UNITED STATES GENERAL ACCOUNTING OFFICE  
WASHINGTON, D.C. 20548

B-203330

NOVEMBER 17, 1982

Subject: Cost Increases, Technical Problems, and Lack of  
User Interest Make Continuation of Helistat Program  
Questionable (GAO/MASAD-83-4)

Figure 1  
ARTIST CONCEPTION OF HELISTAT

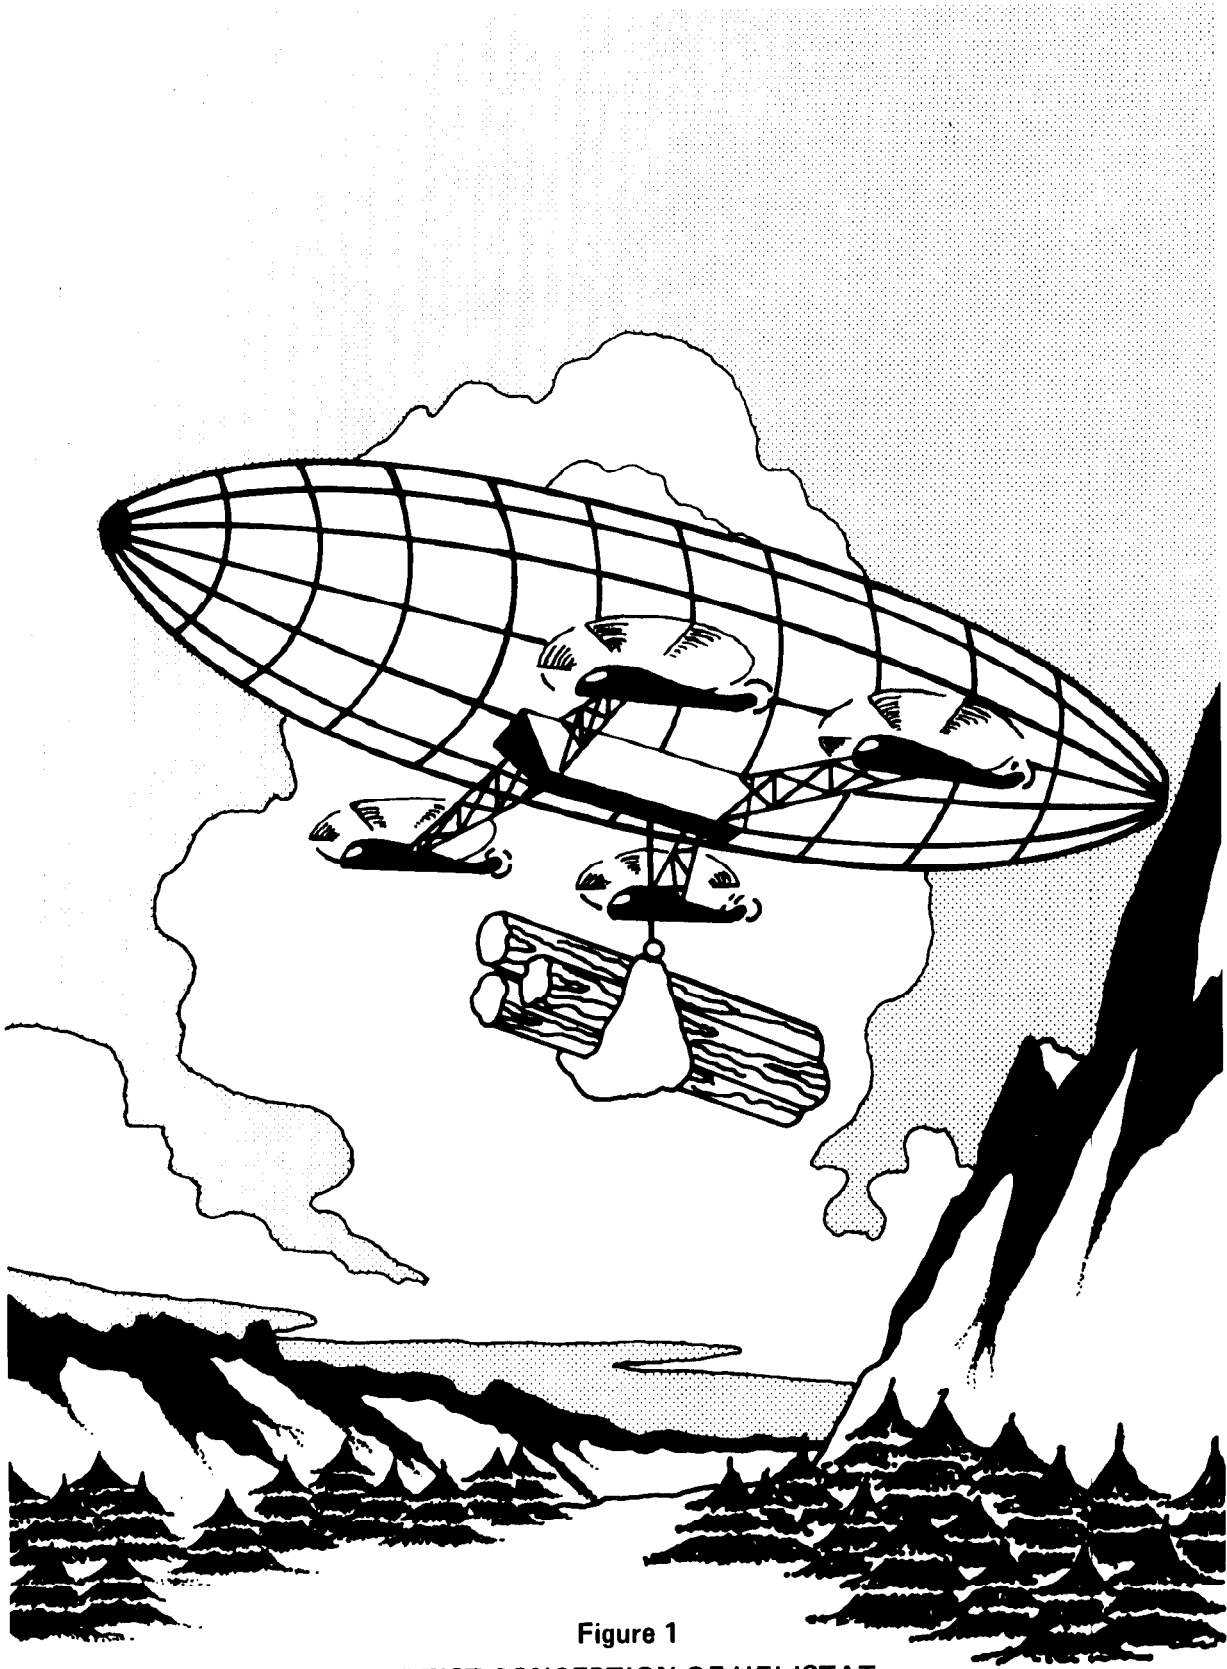
The Forest Service is developing a lighter-than-air vehicle consisting of a 343-foot-long blimp envelope with a frame which has four helicopters attached to it. (See enc. I.) After completing the development program in 1983, the Forest Service then plans to use this vehicle, called the Helistat, to demonstrate that aerial logging operations are economical in steep, inaccessible mountainous terrain.

FIGURE 2

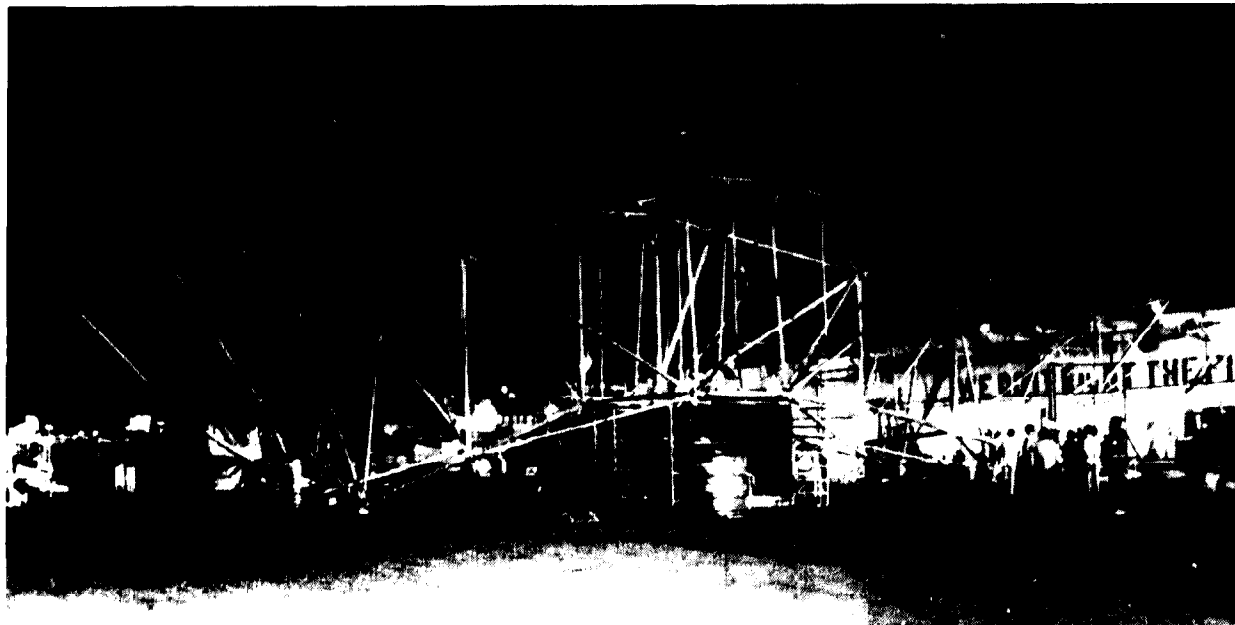
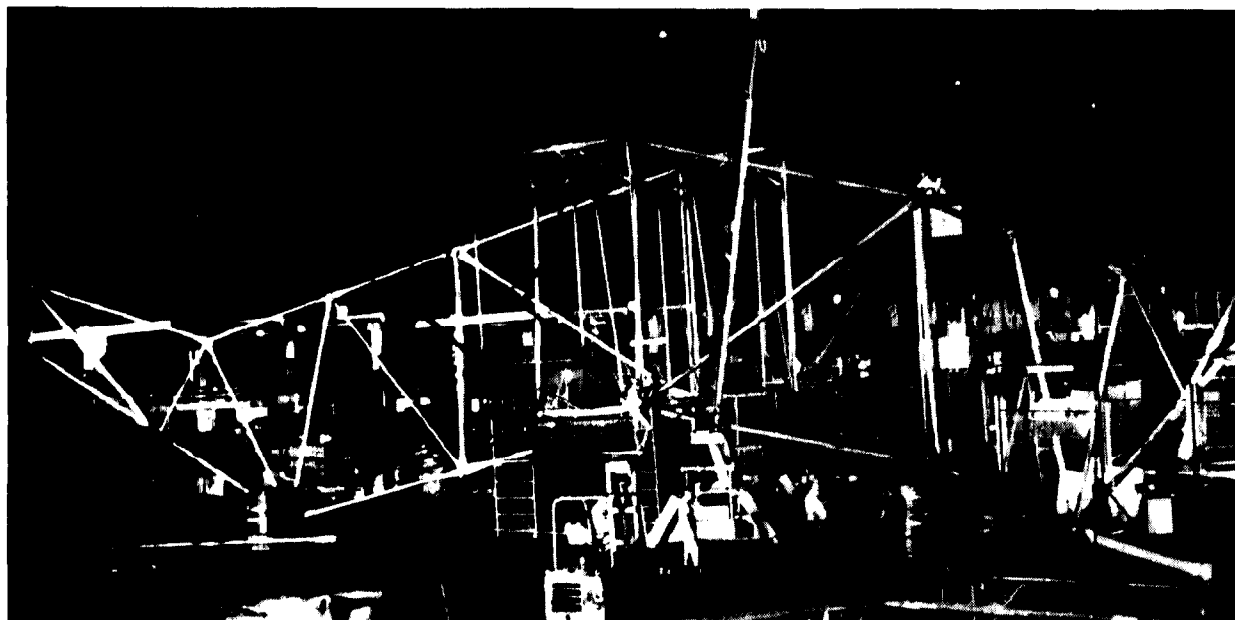
- The concurrent design and fabrication of the Helistat's interconnecting structure has resulted in the rework of items; the redesign of tube ends and tube joint connectors to fasten the structure together; and the field fitting of tubes, tube ends, and connectors.
- Engineering analyses requested to ensure the strength of the structure have been incomplete and flawed.
- Poor quality workmanship practices have been used to build the interconnecting structure.

A material that would be lightweight, yet capable of withstanding vehicle stresses, was needed to build the interconnecting structure that attaches the four helicopters to the blimp. (See enc. II.) Aluminum tubes of different diameters are being used to build the structure. Since tube thickness, diameter, and material directly relate to the stresses it can tolerate, the design and building of the tubular, truss-like structure were of major consequence.

design changes, rework of fabricated items, and adjustments to structural members during assembly. These adjustments included shortening or lengthening tubing to fit, and cutting tubing so that the ends could be rotated for connecting and then placing a collar over the cut tube.

In addition, the Navy has been dissatisfied with the quality of the contractor's workmanship, particularly in the fabrication of the interconnecting structure. Concern was also expressed by a Federal Aviation Administration official during visits to the construction site about the questionable workmanship practices of the contractor. Some of the problems Navy officials identified were

- poor welding,
- out-of-tolerance dimensions,
- spliced and patched tubes,
- scored and dented tube ends, and
- insufficient cleaning of bonded surfaces.

The contractor challenged the poor workmanship concerns, stating that these items are actually work-in-progress and that, before static testing begins, all corrections and/or replacements will be made. The Navy is negotiating with the contractor regarding these corrections and replacements, but no final resolution of these concerns has been achieved.
